UNITED STATES
NUCLEAR REGULATORY COMMISSION

SUBJECT: U.S. NUCLEAR REGULATORY COMMISSION/U.S. DEPARTMENT OF
ENERGY TECHNICAL EXCHANGE AND MANAGEMENT MEETING ON
THERMAL EFFECTS ON FLOW (JANUARY 8 THROUGH 9, 2001)

Enclosure: Summary Highlights of NRC/DOE
Technical Exchange and
Management Meeting on
Thermal Effects on Flow

Ventilation Test Setup - Atlas Facility

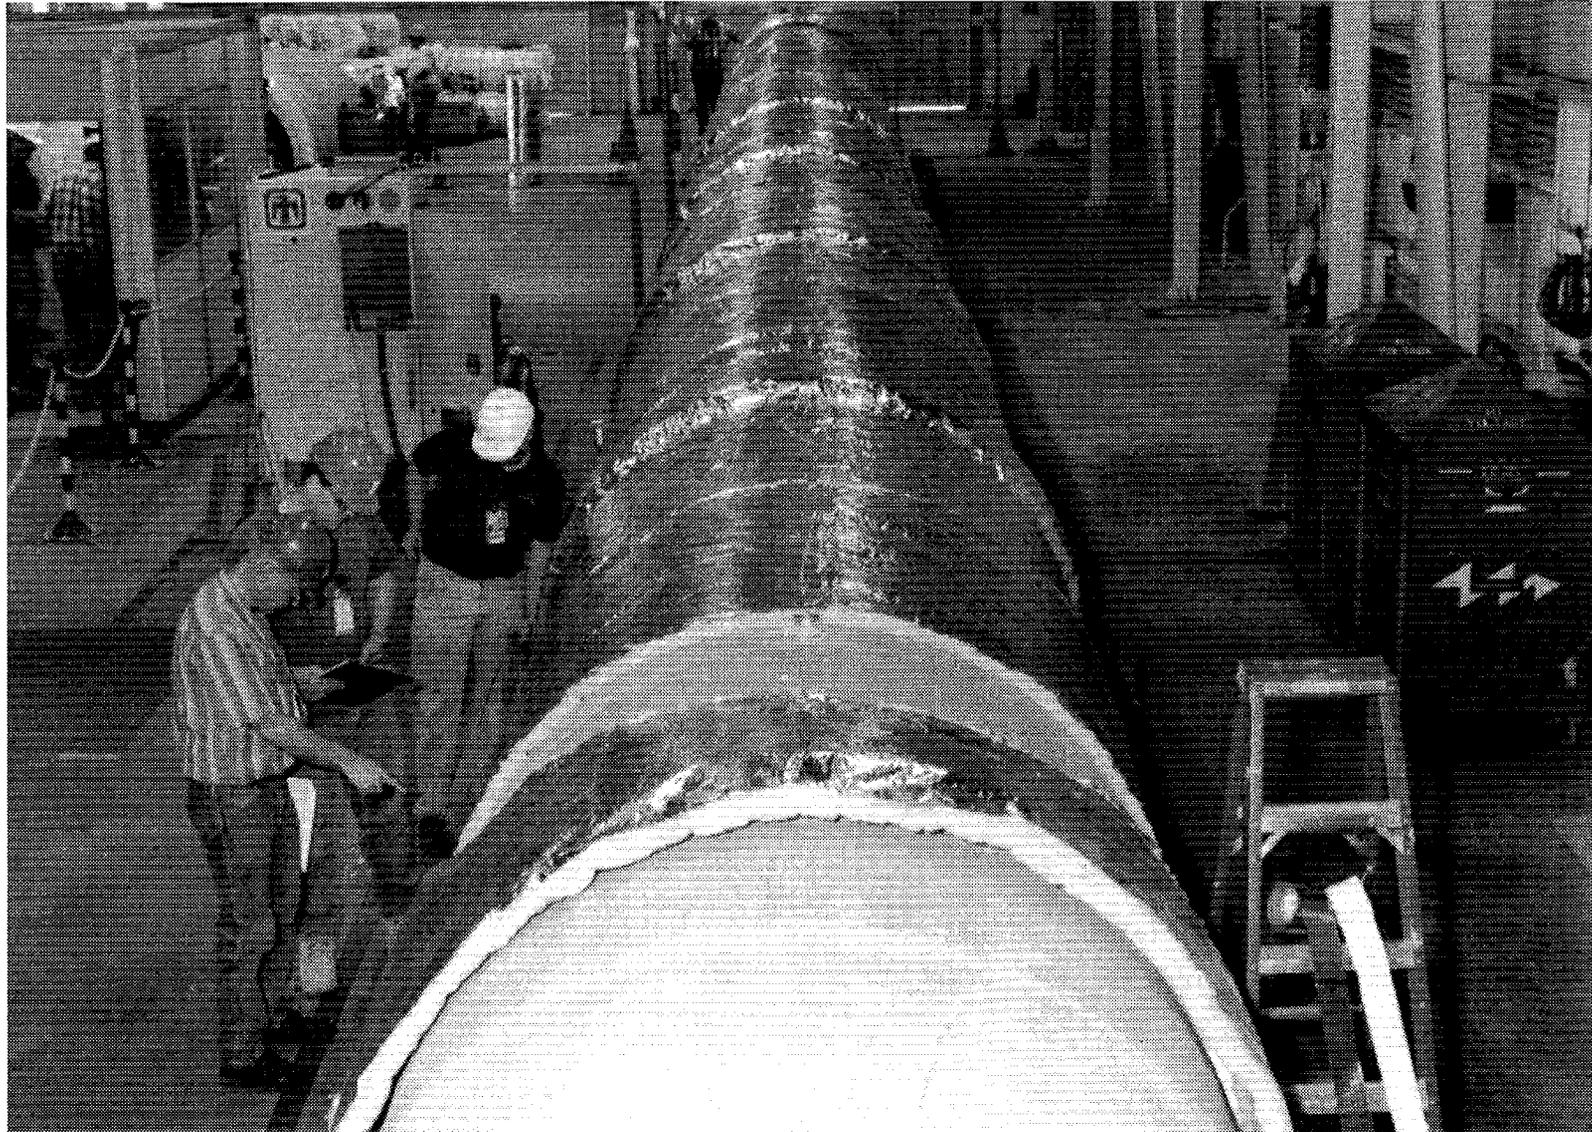
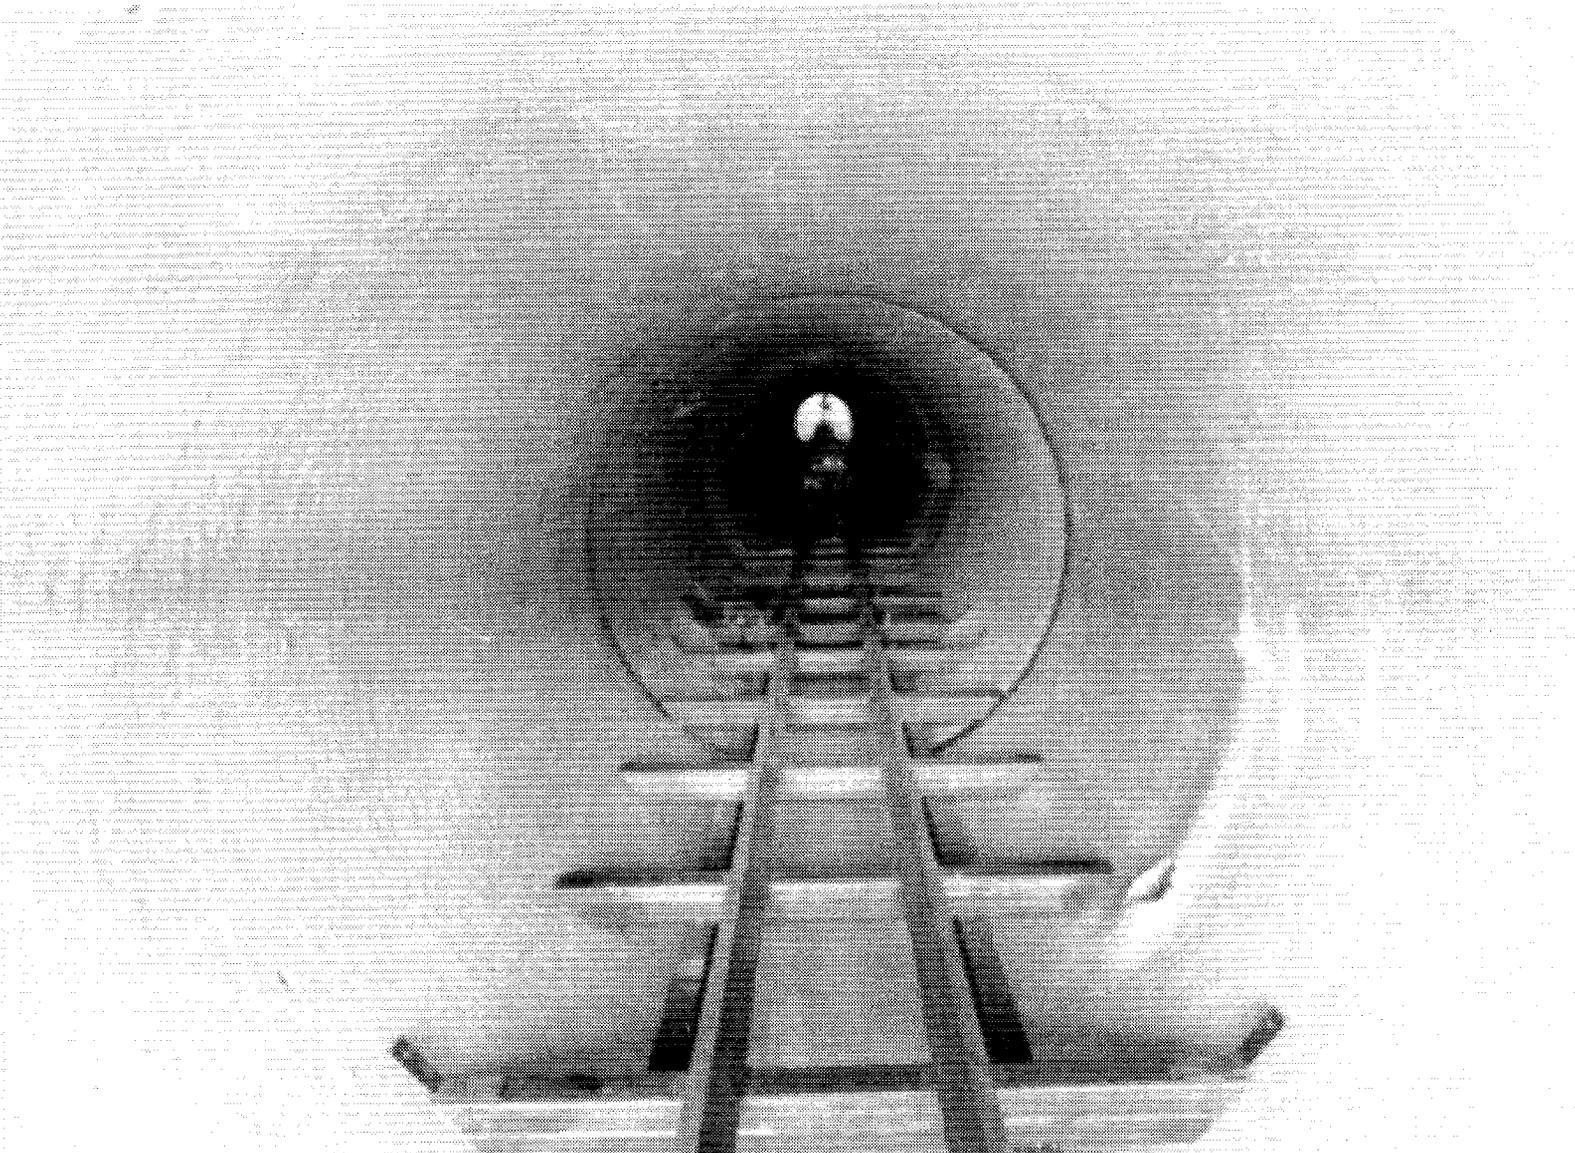
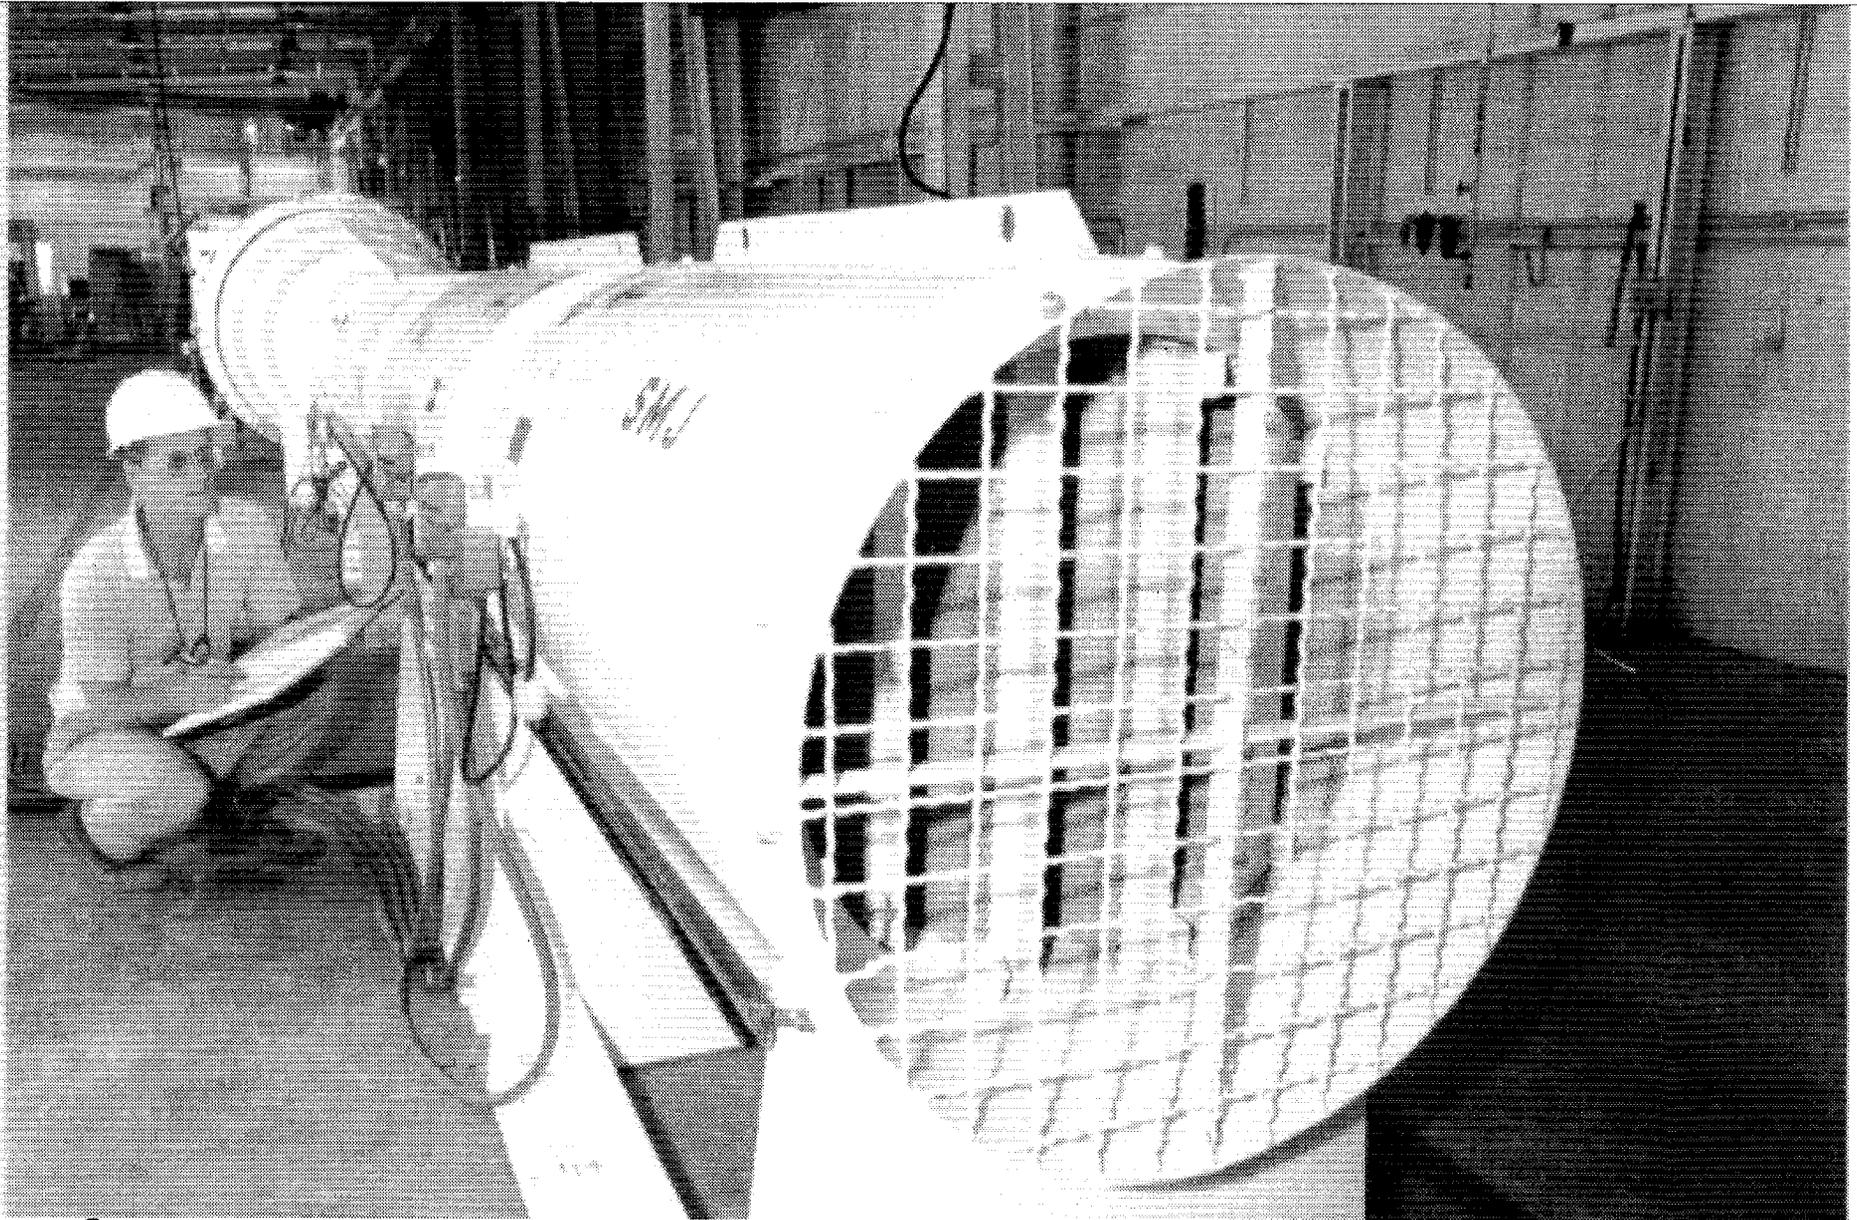
Mr. Shettel (Nye County) questioned the evaporation and precipitation at the drift wall. The DOE responded that the precipitation occurs inside the rock and not at the drift wall. In addition, the DOE stated that calculations could be done to calculate the quantity of minerals precipitated. Mr. Shettel stated that Nye County has already done the calculations and they are presented on the Nye County webpage.

Plan View of Cross Drift Thermal Test Configuration

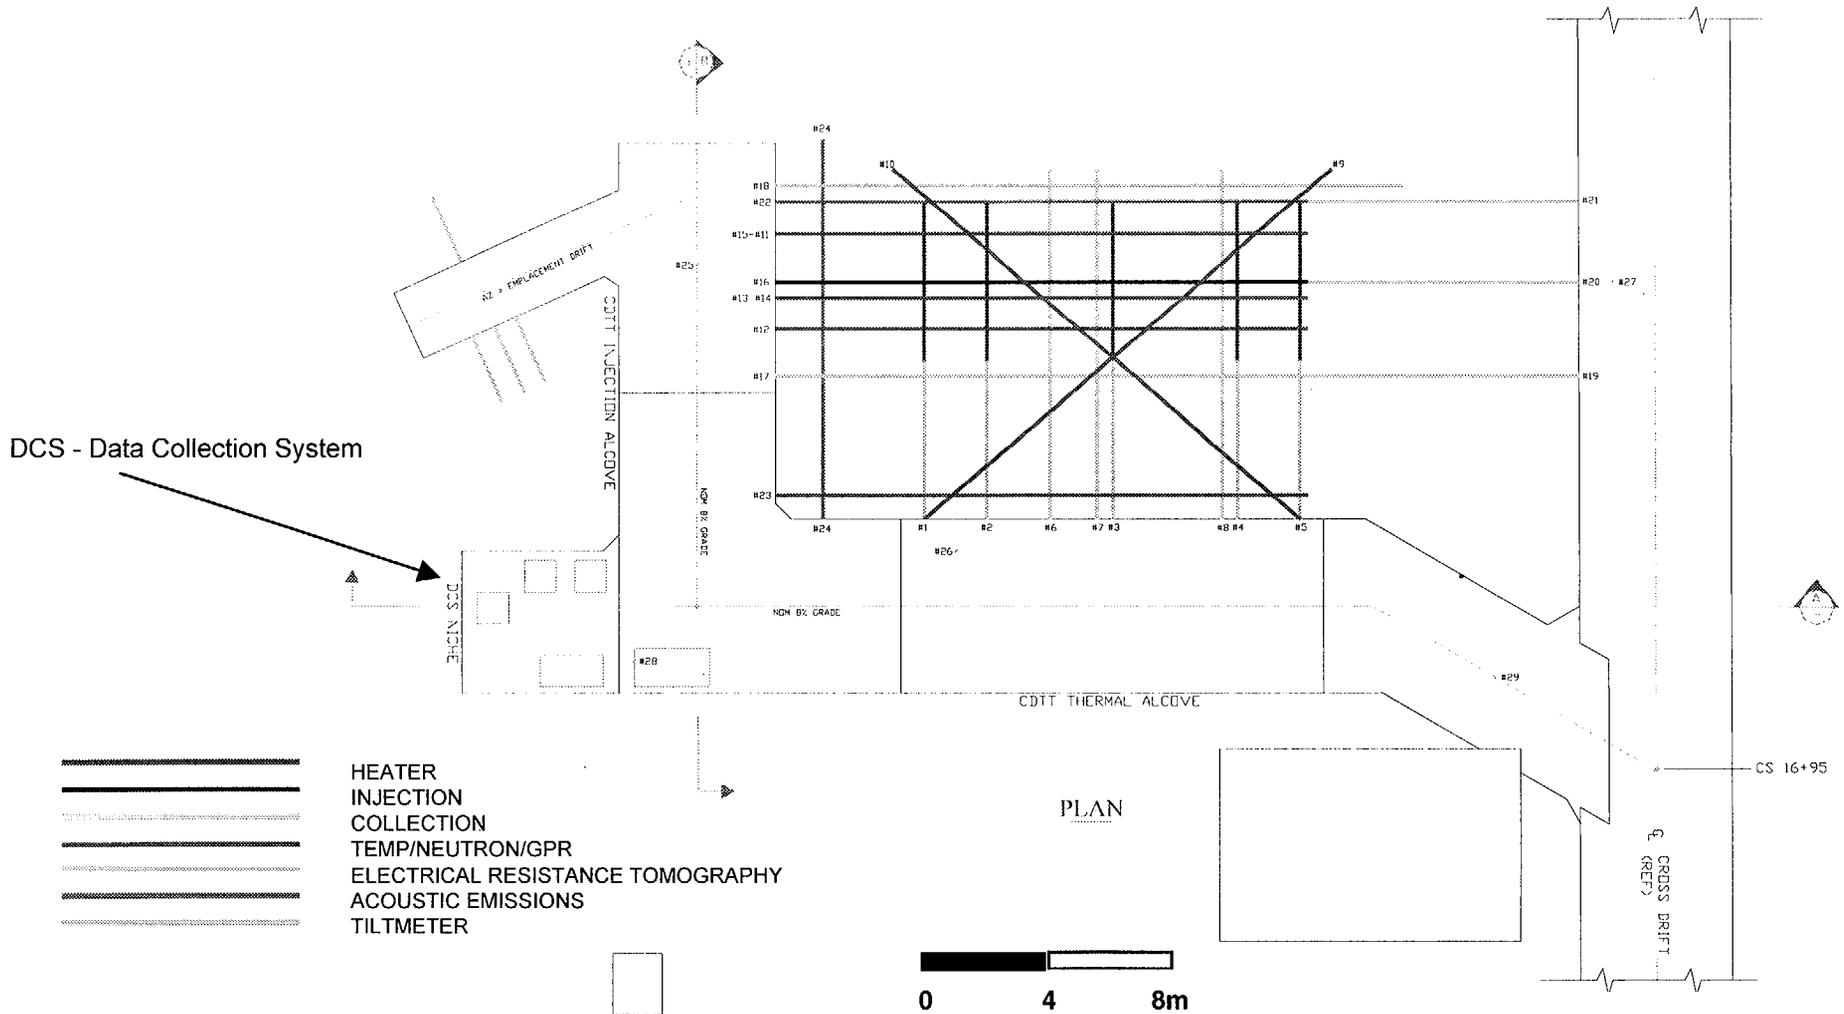
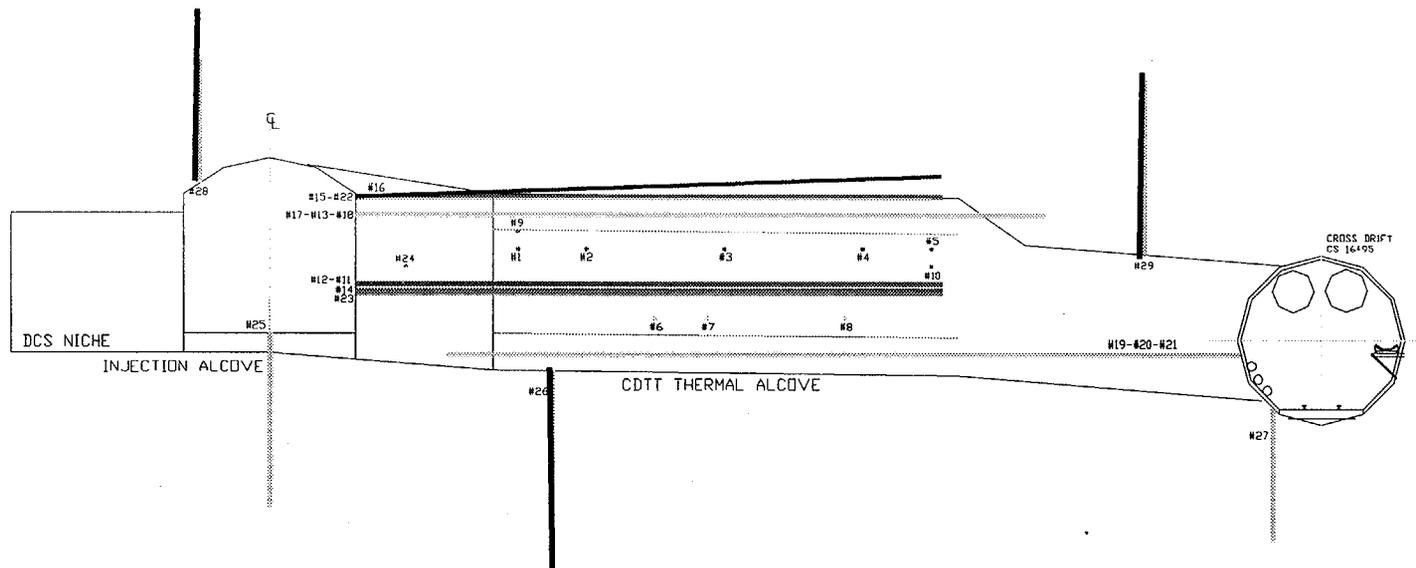
The DOE discussed the test design configuration. The DOE stated that the objectives of the cross drift thermal test include testing water shedding between drifts. The NRC questioned whether the water collection holes would be effective in collecting water and stated that capillary diversion needs to be taken into account. The DOE noted the NRC comment. The DOE stated that there might not be sufficient water for collection in the collection holes. The DOE acknowledged that conclusions on whether thermal seepage into emplacement drifts occurs could not be drawn solely on the basis of no water accumulating in the collection holes. Similarly, the DOE acknowledged that chemical analyses of liquid water cannot be undertaken if no water accumulates in the collection holes. The DOE stated that the Cross Drift Thermal Test Final Report is scheduled for December 2004 in the present baseline schedule.
